PRIMARY CHAIN TENSIONER / 1200; 1340 MODELS

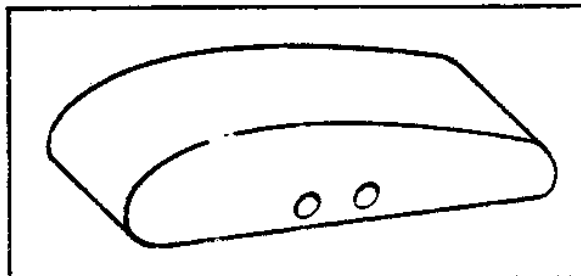
The material used for the primary chain tensioner has recently been changed from a black color polyethylene to a white color Zytel material for improved durability and resistance to wear at high temperatures. Some accelerated tensioner wear has been reported under severe operating conditions at high air temperatures. This condition has not been experienced under normal operating conditions.

The black polyethylene tensioners were used in late 1978 and early 1979 FL and FX series motorcycles within the following range:

VIN 2A/2C/2F/5E/9D or 3G:

21911 H8 to 29960 H8
60000 H8 to 79676 H8
10000 H9 to 28846 H9.

The improved shoe white Zytel material was used in motorcycles above 29846 H9 and these motorcycles will not require tensioner change.

To prevent any possibility of a problem in motorcycles in service we request that you replace all existing black tensioners in customers' motorcycles at no charge. We also request that you replace all tensioners of affected motorcycles in your store and in your parts inventory as soon as possible.

Order any additional requirements of the new tensioner under part No. 39976-65B. At the same time, order the required number of chain cover gaskets, part No. 60540-65A. As a basis for ordering, use the quantity of vehicles within the affected VIN range which were shipped to your dealership.
